CONVAIR

COMMERCIAL CHANGE PROPOSAL

SPEC NO.: ZD- 22-002

MODEL: 22-1 (Convair "880")

Page 2A, Figure 1-1 GENERAL ARRANGEMENT:

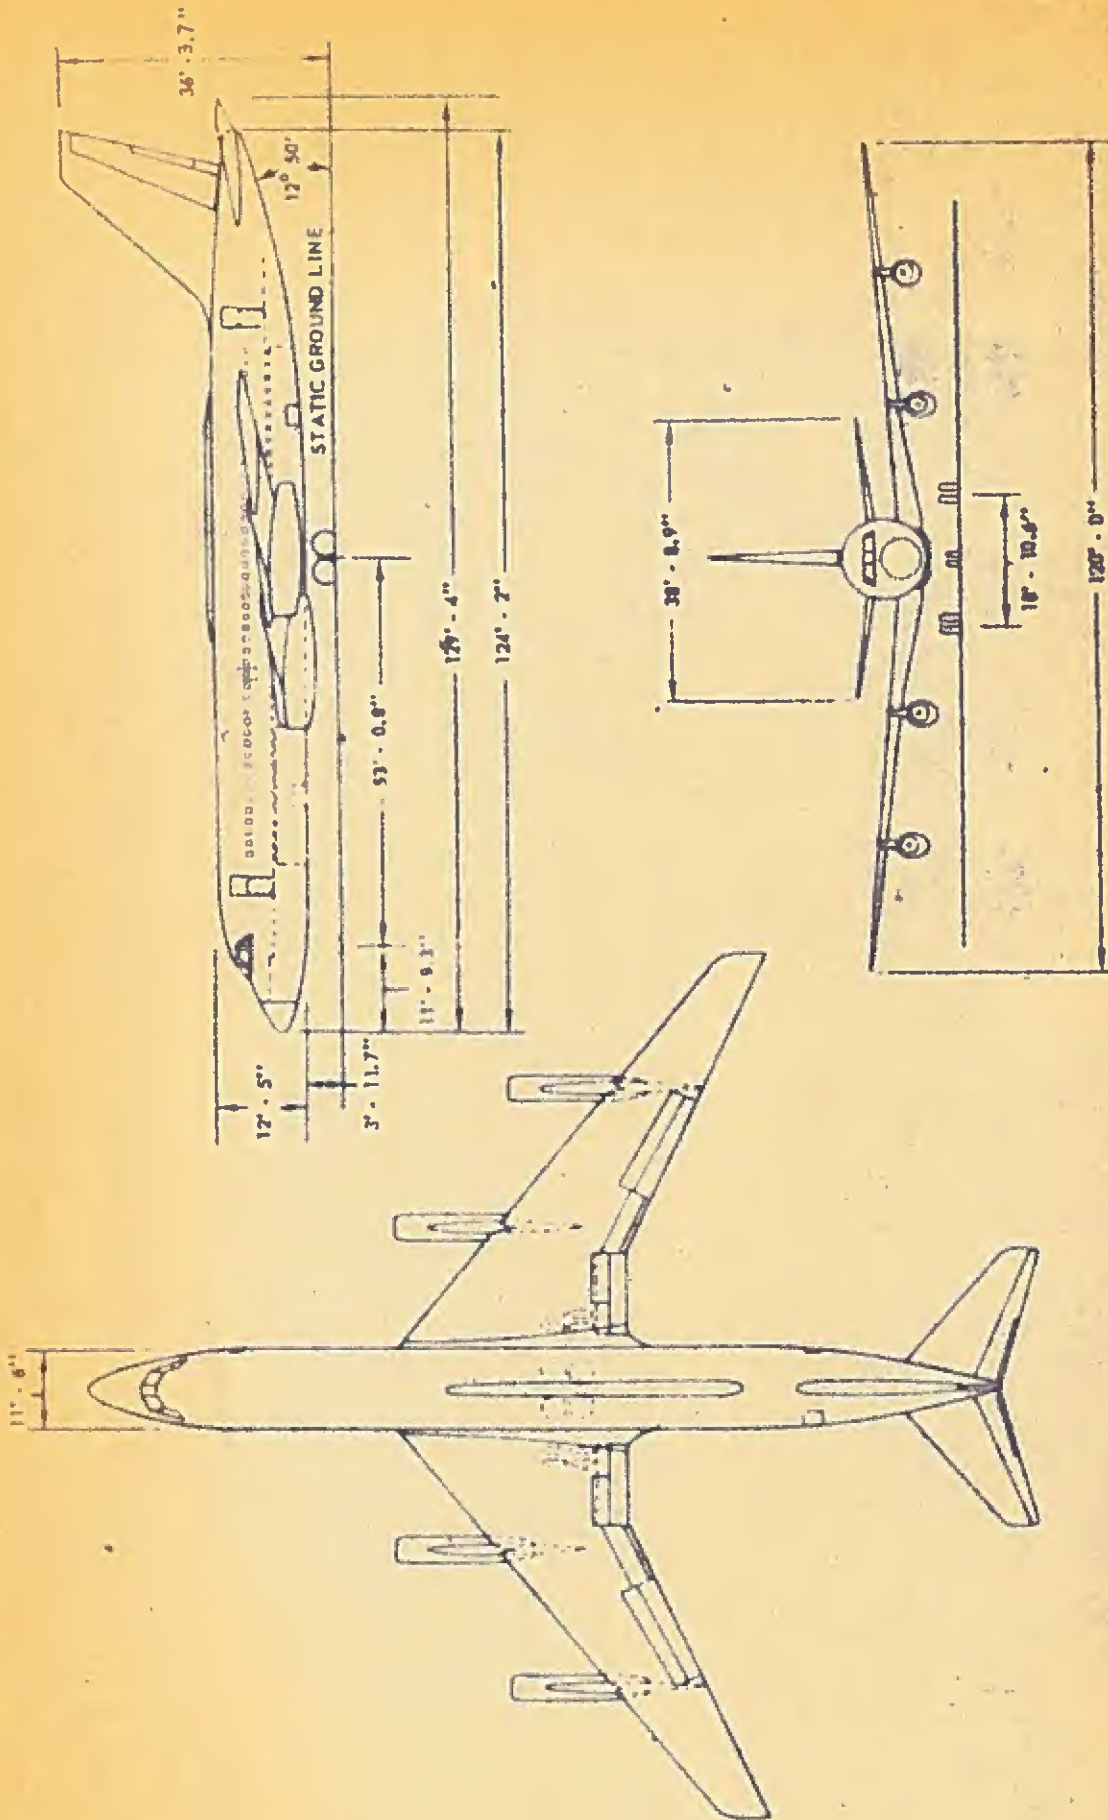
Add the following items to the equipment list:

Enclosure: (A) one (1) copy of Figure 1-1 GENERAL ARRANGEMENT:

Figure 3.19-4

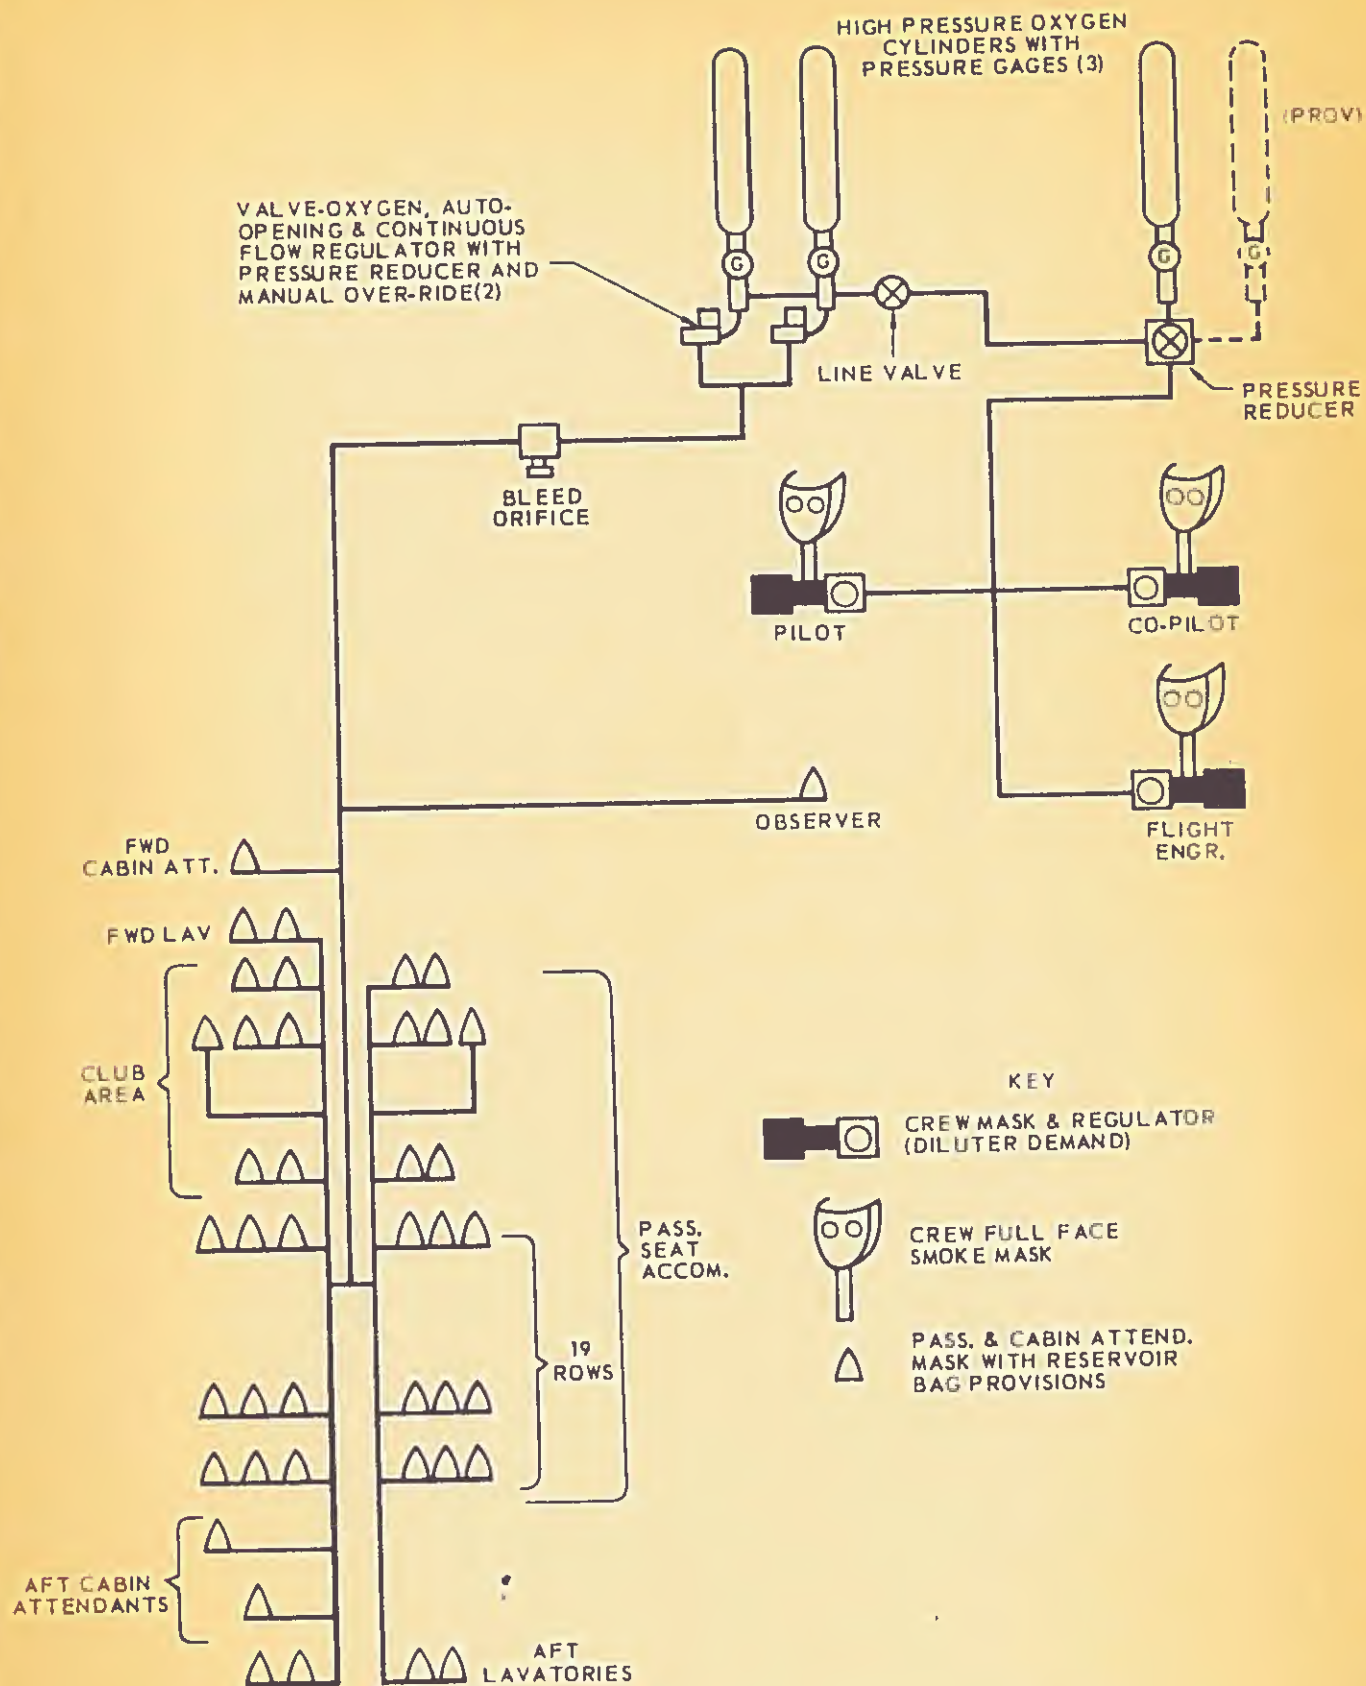
Provisions for one additional mask shall be made for each seat row in the main cabin area (three masks for each of the 19 rows on both sides of the airplane) to provide for emergency oxygen for children in arms. The oxygen outlet system for the club area shall be as shown on Figure 3.19-4

Above figure will be replaced in the specification with Enclosure (A) on Customer approval of this CCP.

Enclosure: (A) One copy of Figure 3.19-4 - GASEOUS OXYGEN SYSTEM (Revised)

FIGURE 3.19-2

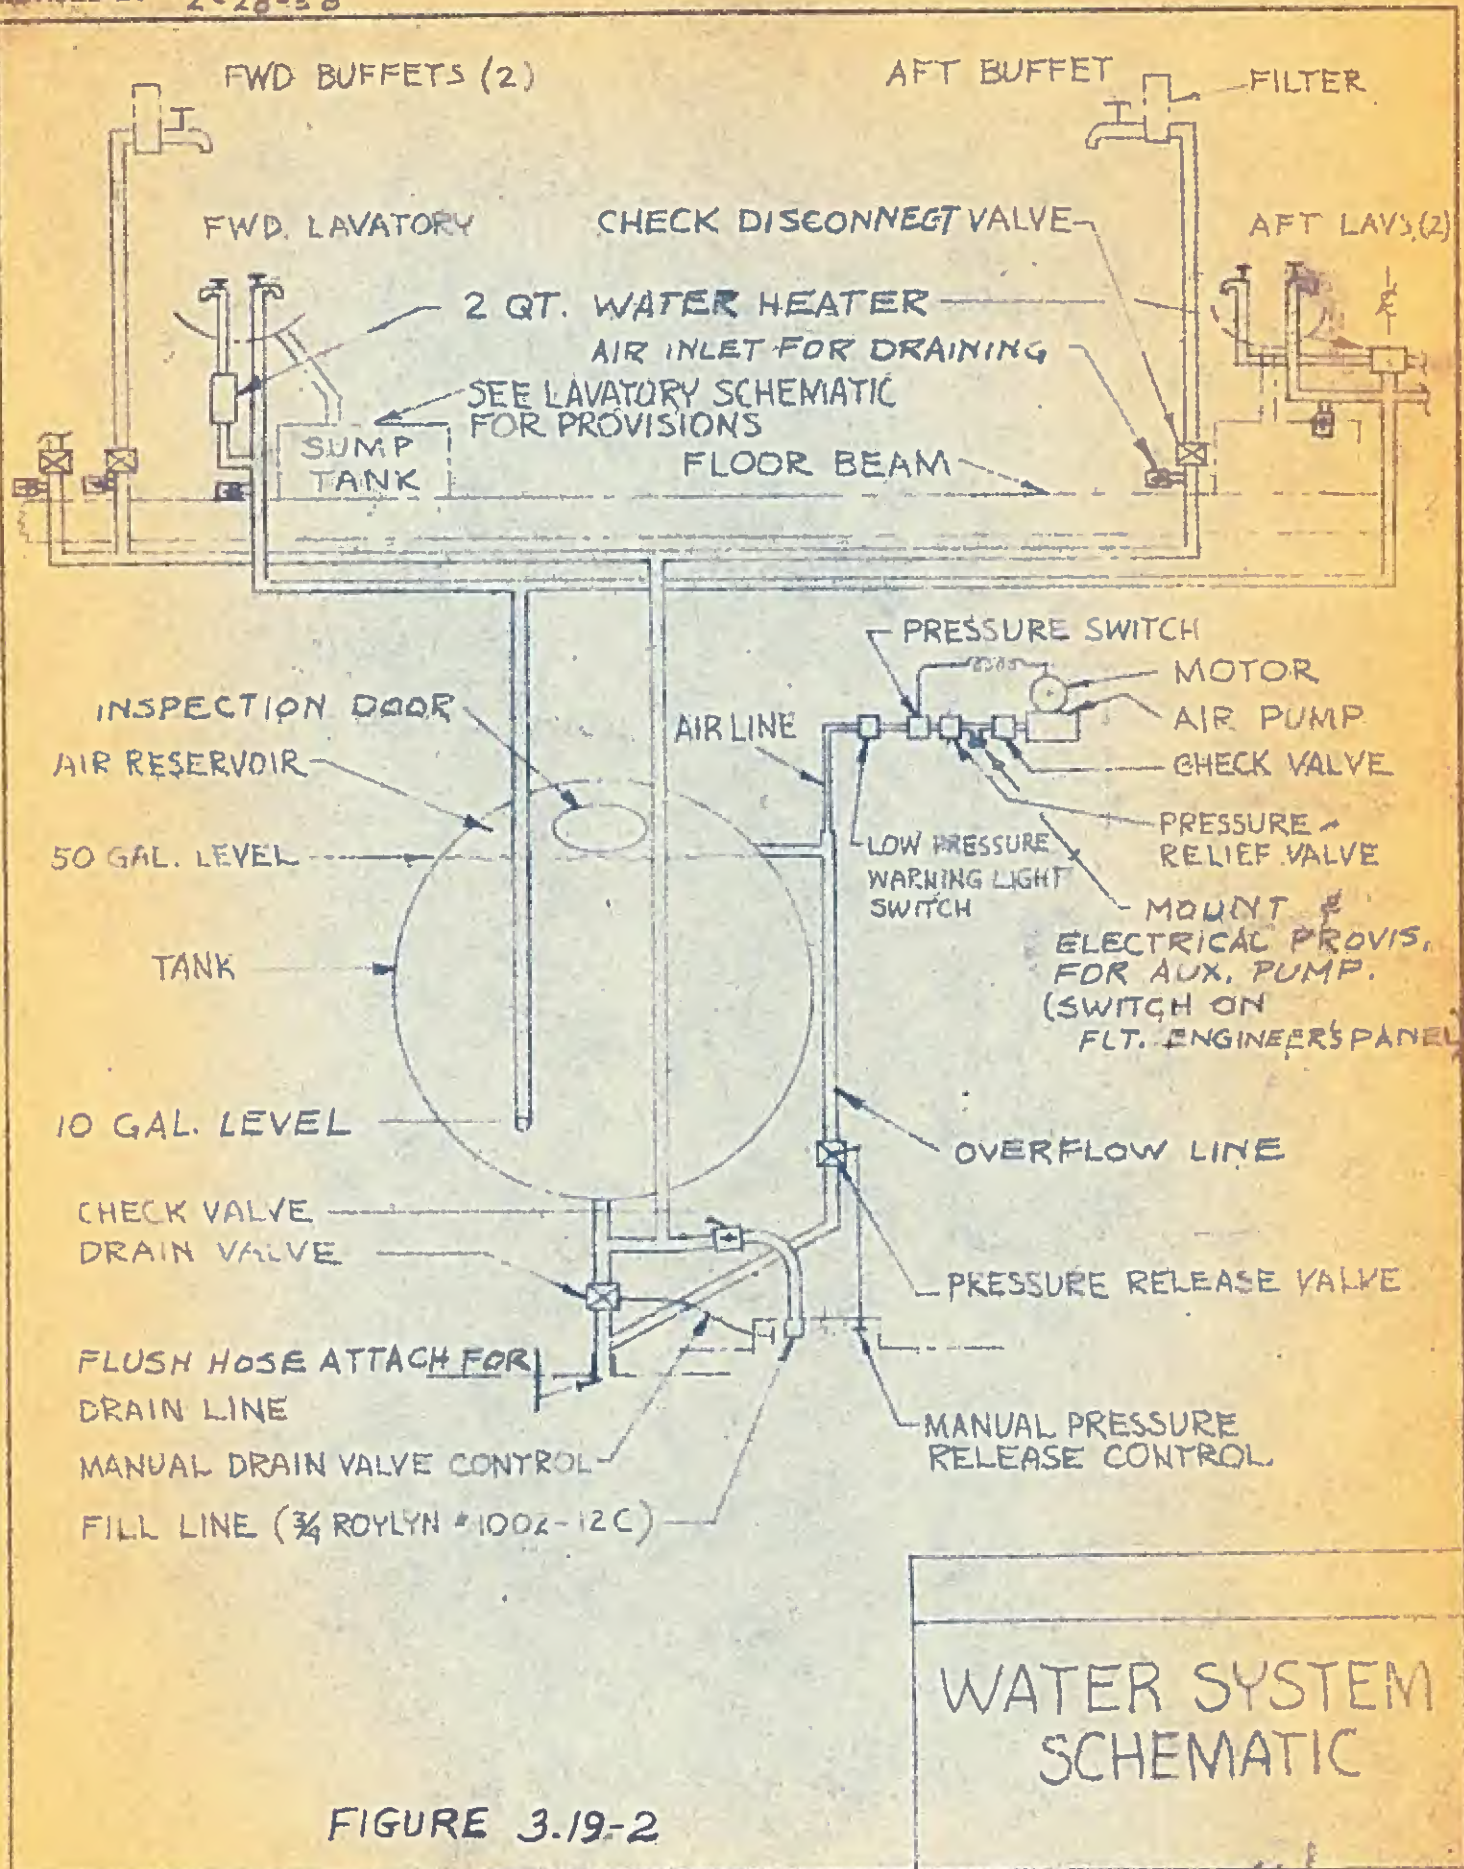
Page 110B FIGURE 3.19-2 WATER SYSTEM:

Enclosure: (A) One copy Figure 3.19-2, WATER SYSTEM SCHEMATIC (for information only)

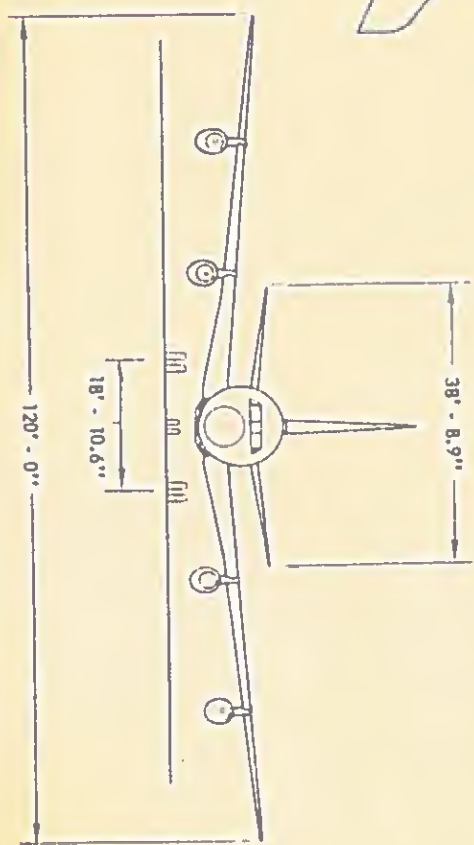
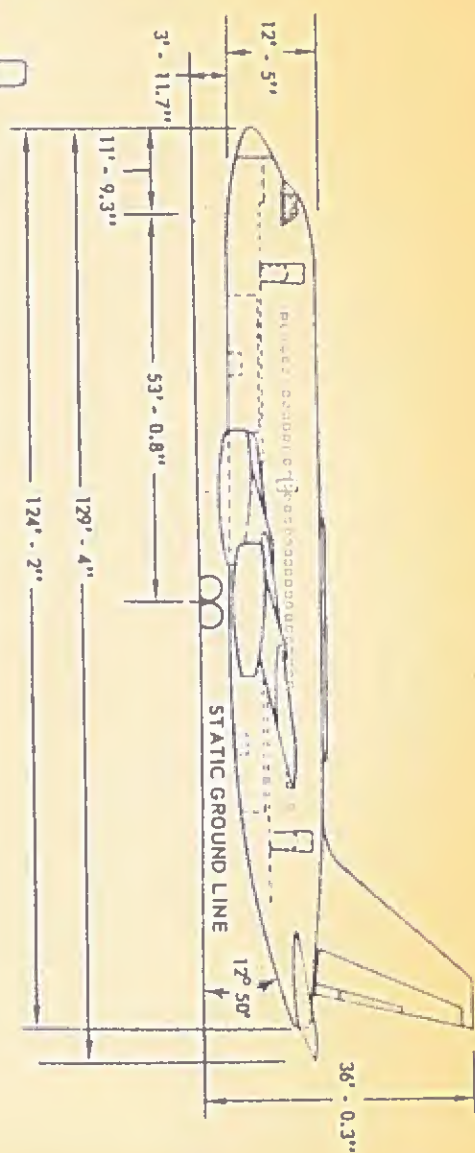
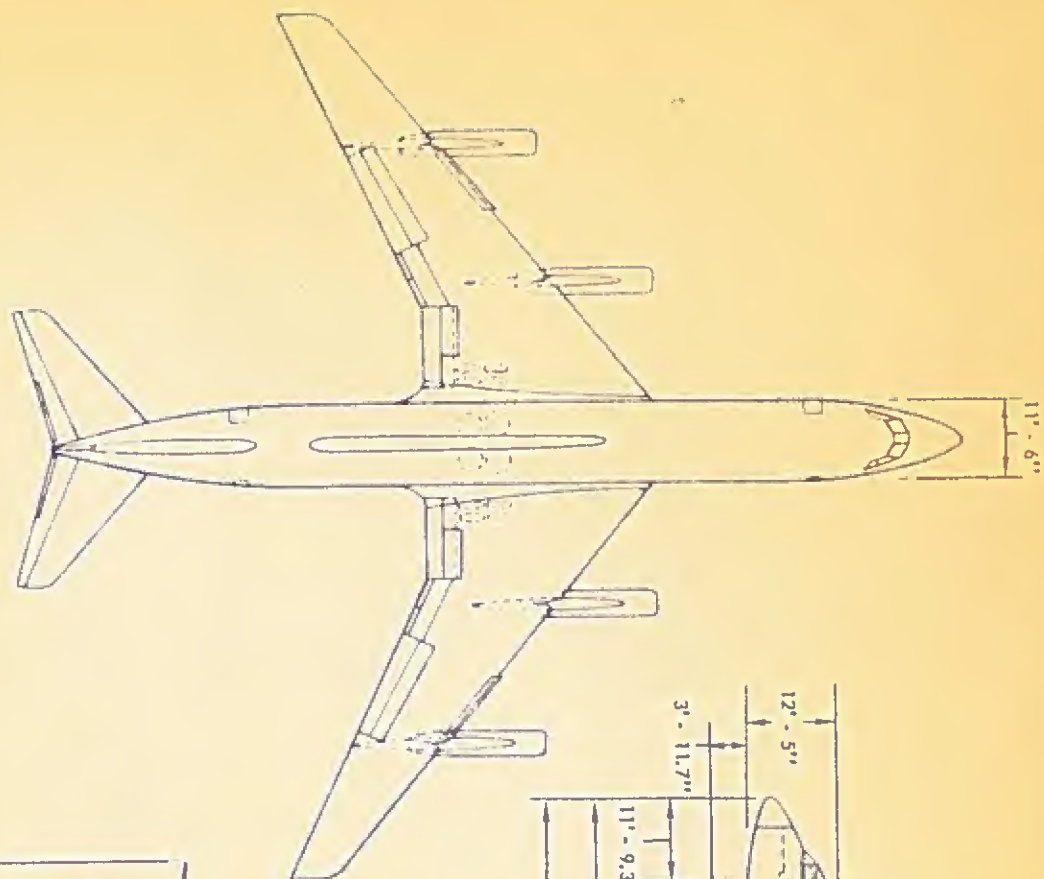
Add the following item under paragraph "4. Inherently Interchangeable Parts"

"Leading Edge Slats"

- Enclosures: (A) One copy of Figure 1-1, GENERAL ARRANGEMENT (for information only, figure in Specification will be revised to show leading edge slats on acceptance of this Change)
- (B) One copy of Convair Drawing SD-58-03147 - WING L.E. SLAT (for information only)

Page 106, Paragraph 3.19.1.1.5 PASSENGER SEATS:

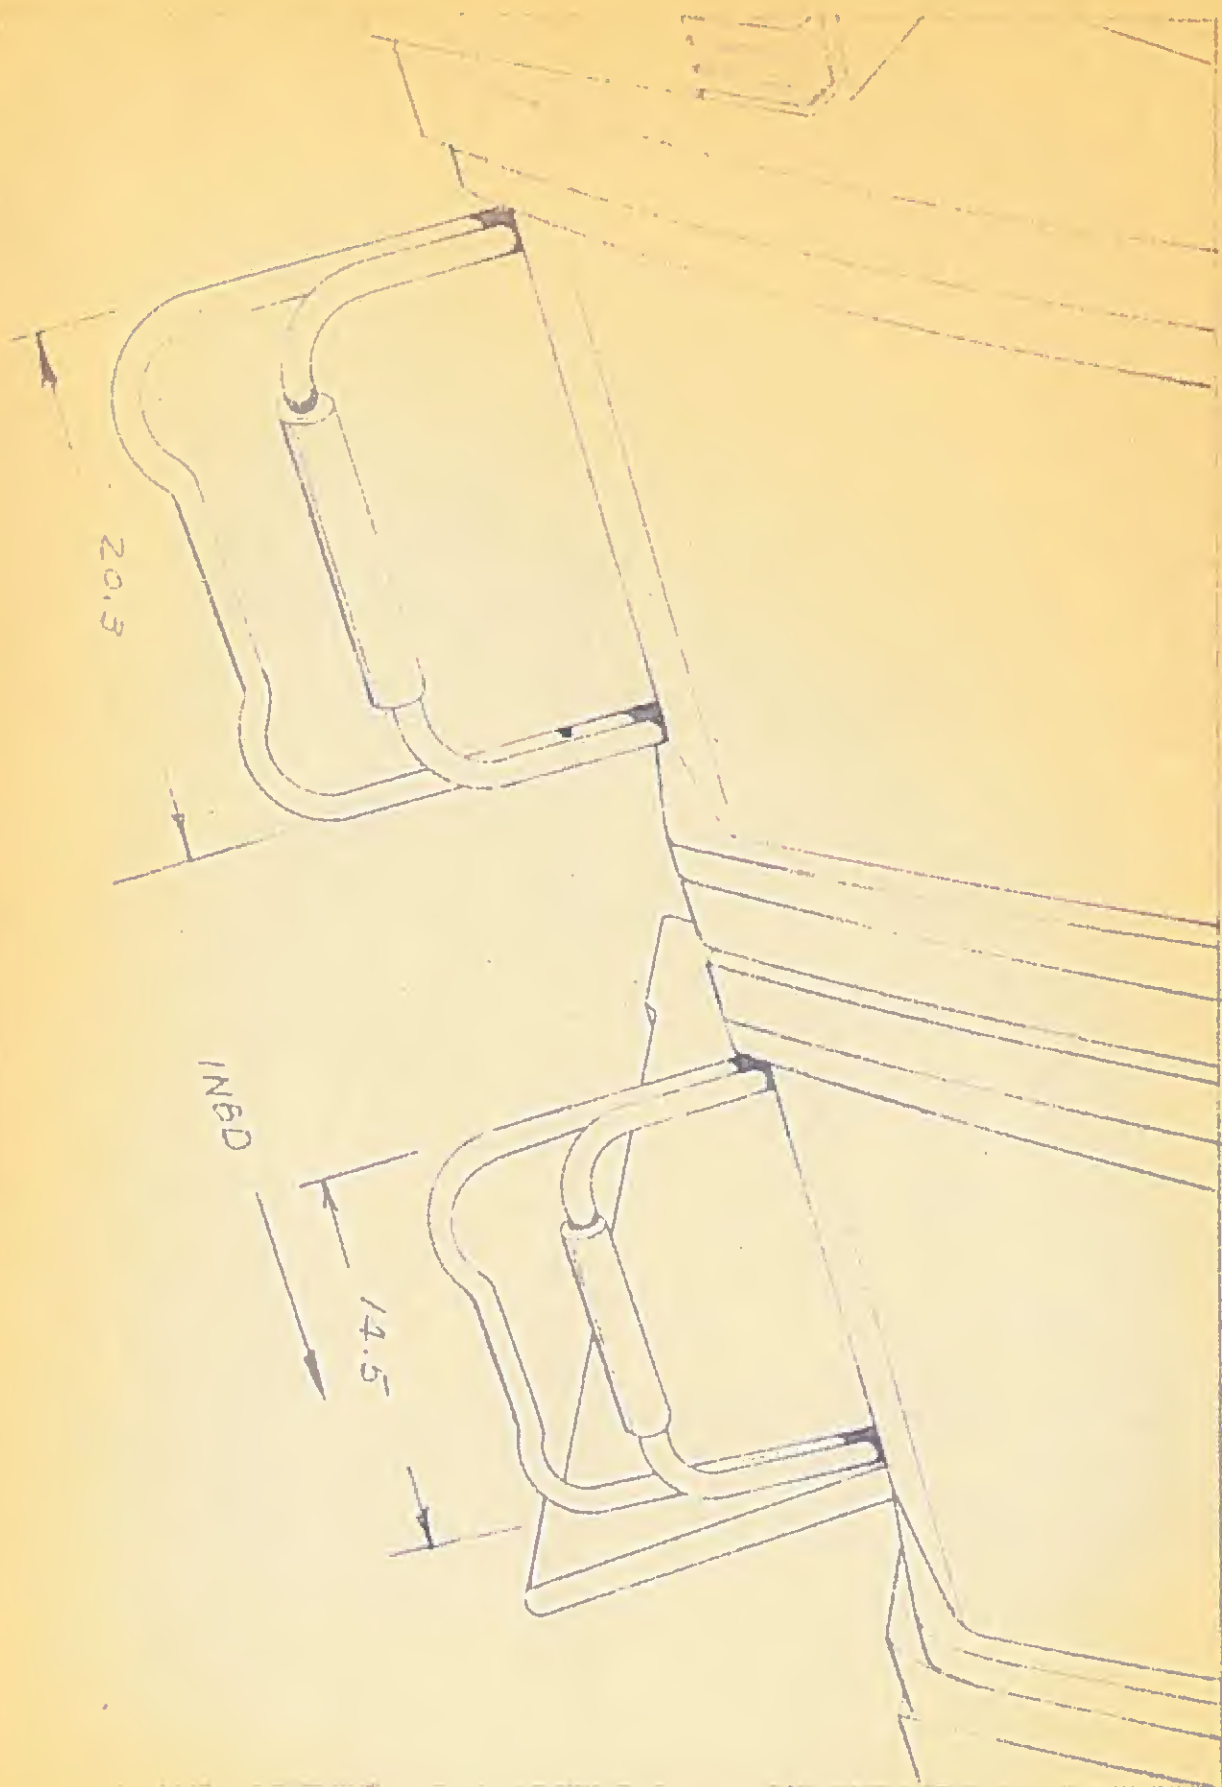
"A two-position foot rest, attached to the rear beam of each cabin passenger seat structure, except last seat row, shall be installed for use of each main cabin passenger except those occupying the front row seats and those immediately aft of the movable coat dividers".
